CSC5/S1NMA Approved Ref: 2017/6270/P Section AA (Bonny Street)

CSC6/S73 Proposed Section AA (Block B)

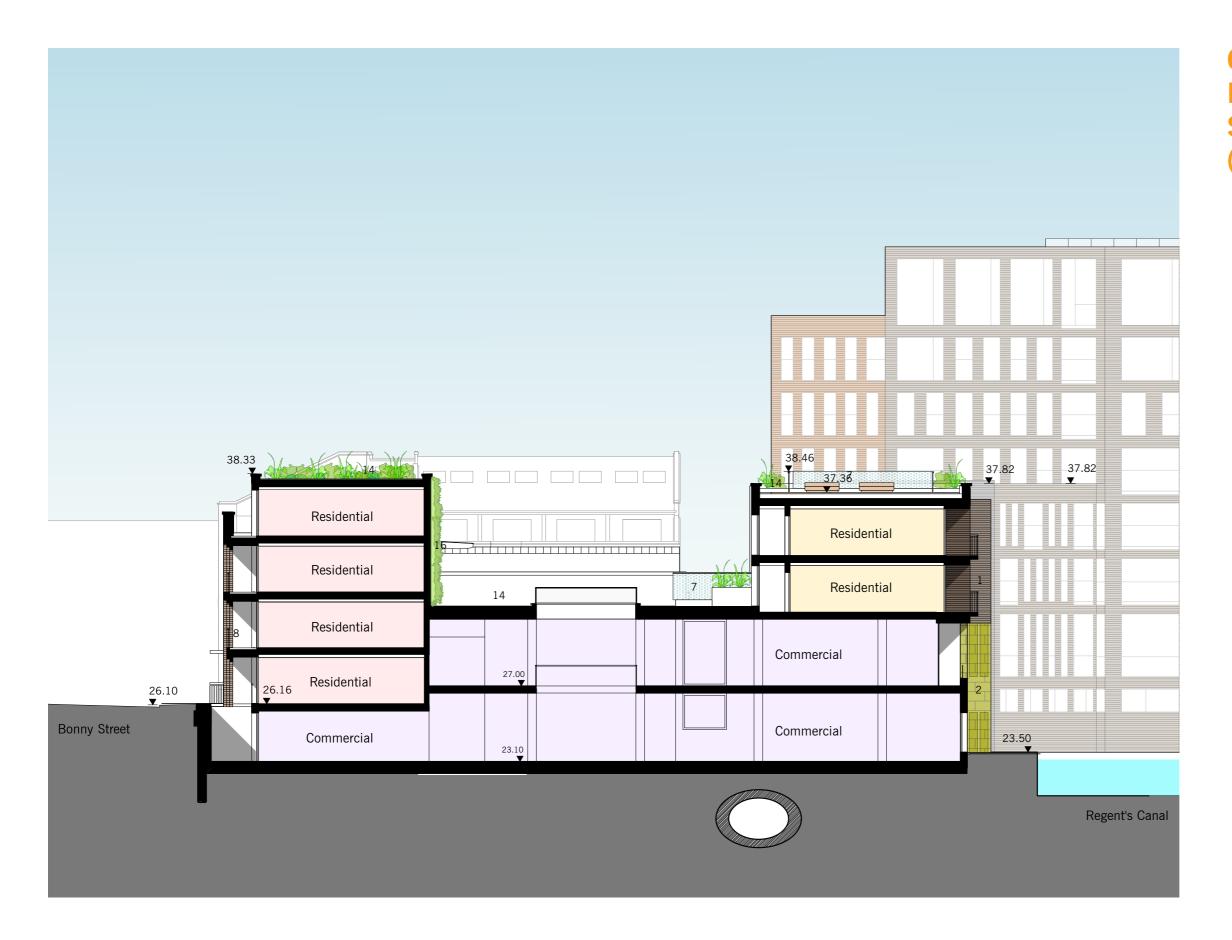
R.6) Mix of flats in Block A,B & C amended R.7) Lightwell to rear of Flat A1.1 enlarged. R.12) Roof above the fourth floor of Block B revised, access stair omitted, communal terrace enlarged, AOV repositioned.

C.6) Level of roof above ground floor commercial space raised.

CSC6/S73 Proposed Section BB (Block A & Block C)

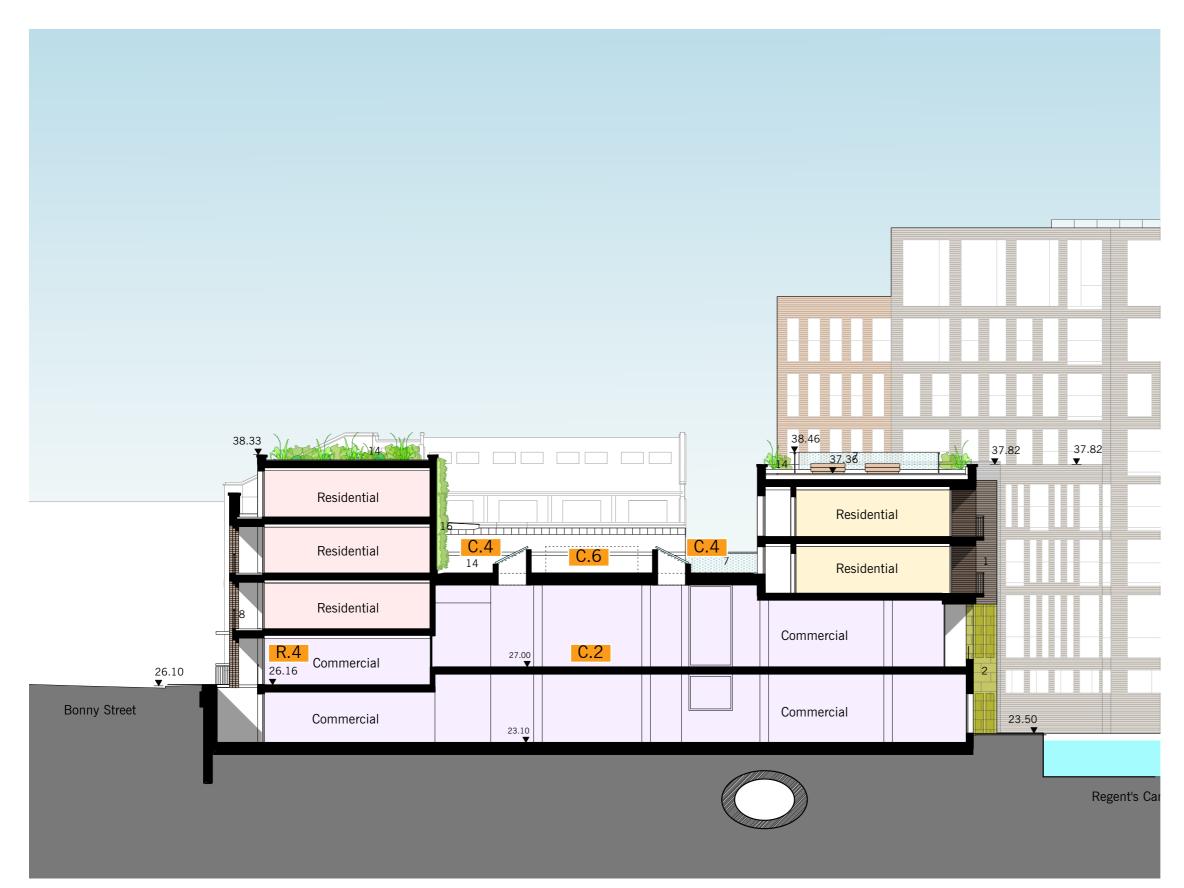
R.4) Wheelchair unit repositioned to first floor.

- C.2) Floor void omitted.
- C.4) Roof light design revised.
- C.6) Level of roof above ground floor commercial space raised.
